APPENDIX E - CHRONOLOGY OF EVENTS

CHRONOLOGY OF DEVELOPMENT PROPOSAL – CLOSEBOURNE RESIDENTIAL CARE FACILITY

DA 18-2086 – HUNTER AND CENTRAL COAST JOINT REGIONAL PLANNING PANEL MEETING 16/17

Clause 5.4 CMP – Development zones

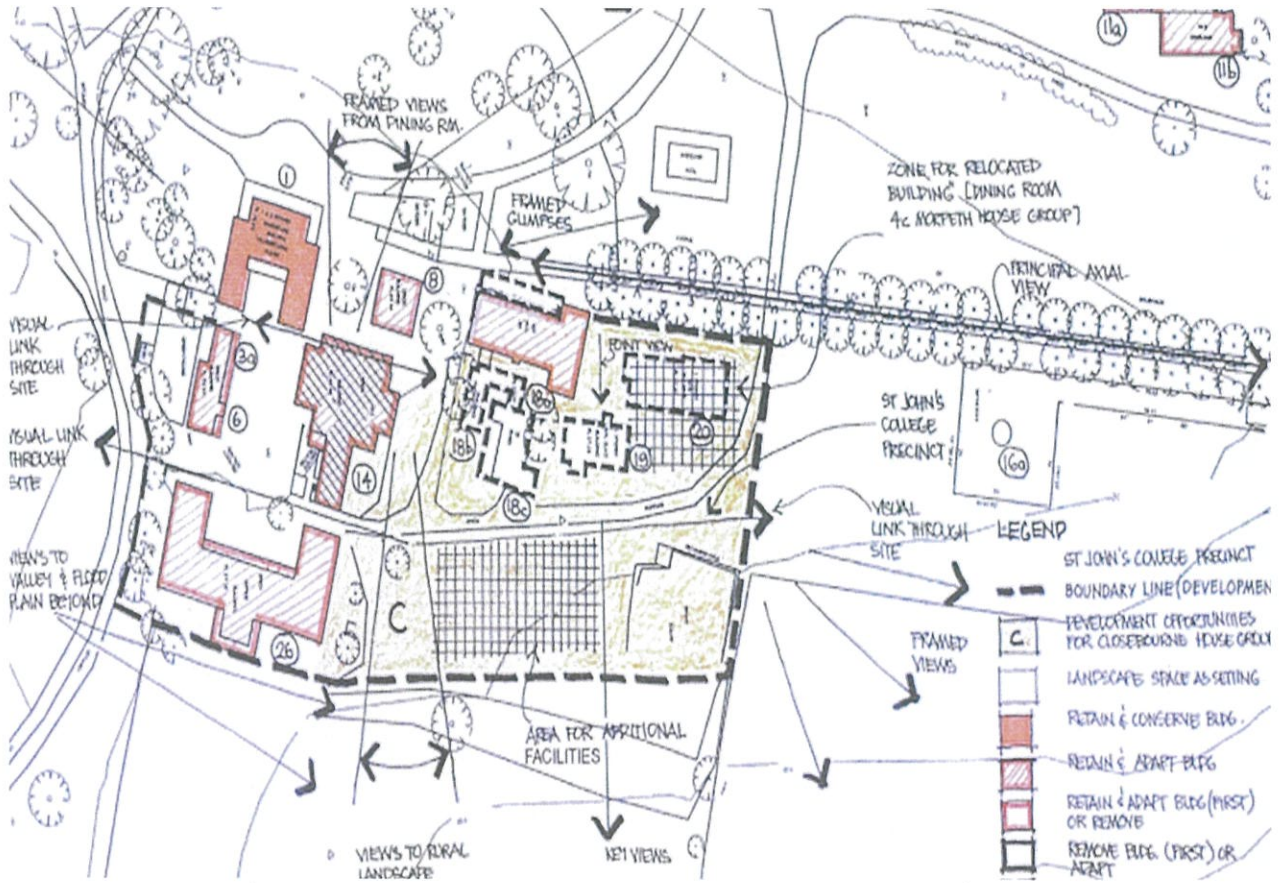
Condition 5 - Any development in the Closebourne House area shall be in accordance with the policies of the CMP and specifically figure 5.4 of the CMP. (See attached Clause 5.4 diagram at the end of this chronology).
